BELLE CHASE SUBDIVISION

APPLICATION NUMBER 18 DATE July 10, 2003

APPLICANT Belle Chase Subdivision, 2nd Addition

REQUEST Subdivision

BELLE CHASE SUBDIVISION, 2ND ADDITION

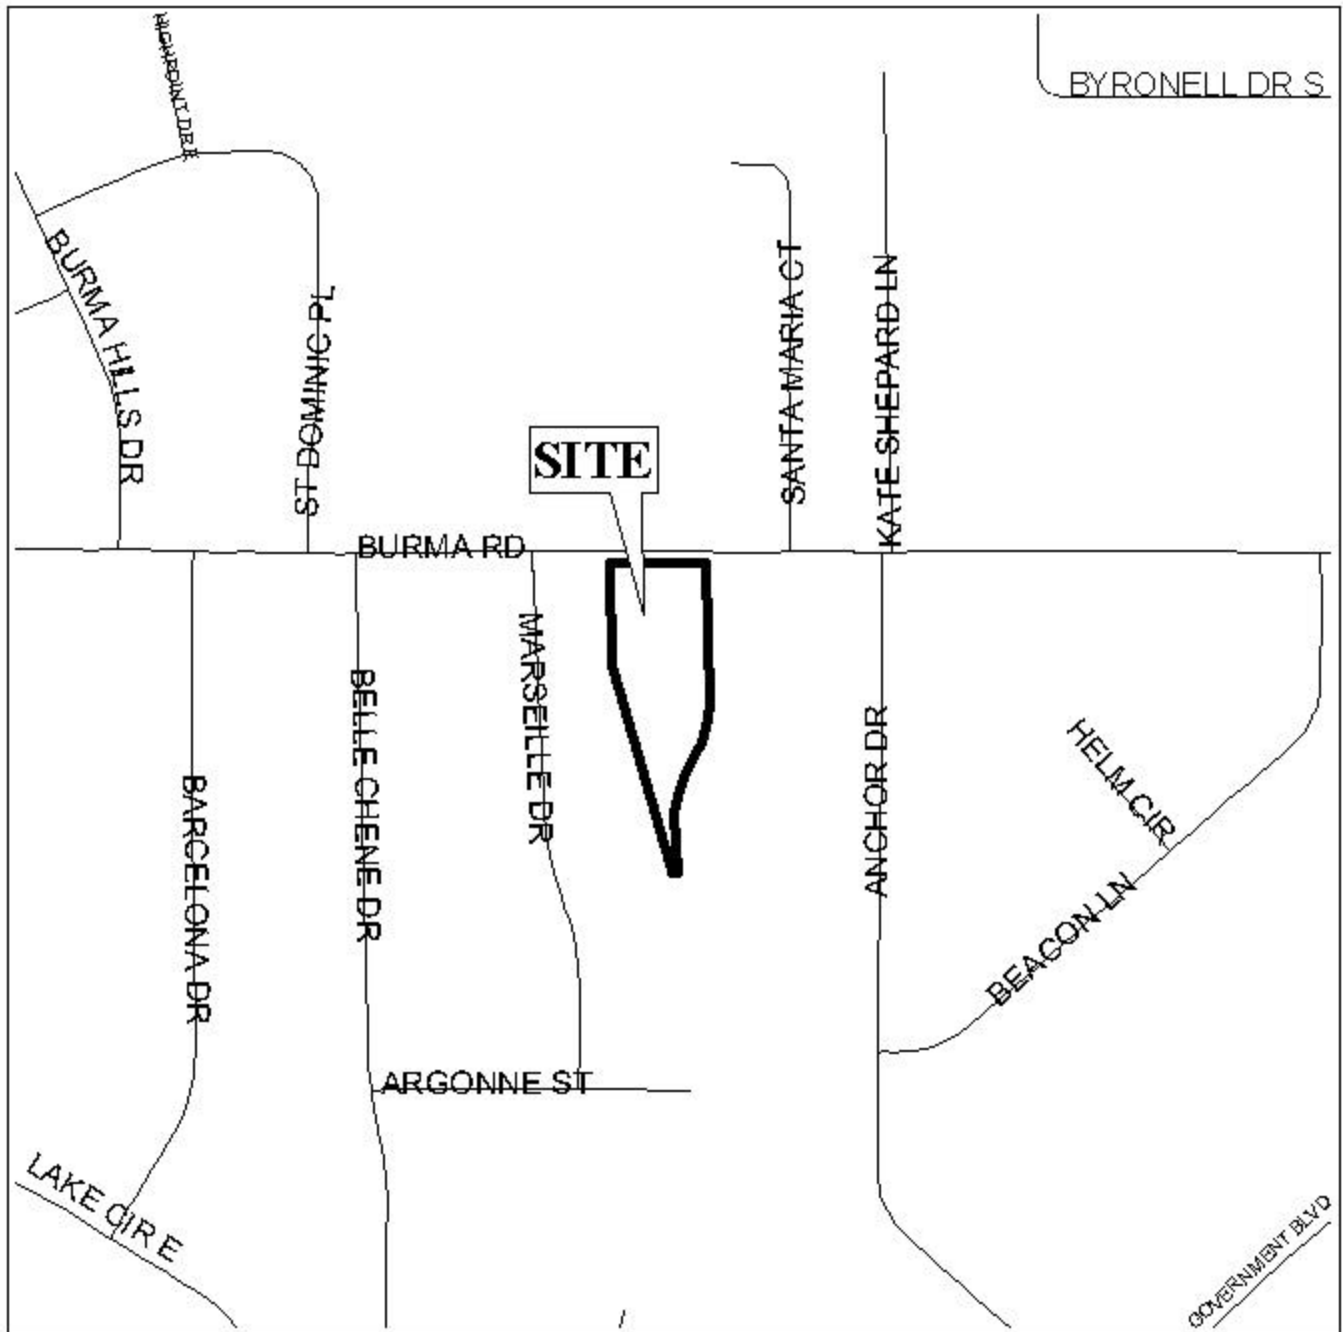
Engineering Comments: Must comply with all stormwater and flood control ordinances. Any work performed in the right-of-way will require a right-of-way permit.

Traffic Engineering Comments: Driveway numbers, size, location and design to be approved by Traffic Engineering and conform to AASHTO standards.

The plat illustrates the proposed 3 lot, 1.5 \pm acres subdivision which is located on the South side of Burma Road, 115' \pm East of the Marselle Drive. The subdivision is served by public water and sanitary sewer.

There is an existing residence on Lot 1, thus a minimum setback of 8-feet must be provided along the proposed East side property line.

The plat meets the minimum requirements of the Subdivision Regulations and is recommended for Tentative Approval subject to the following conditions: 1) the provision of an eight foot minimum side yard setback along the East property line of Lot 1.
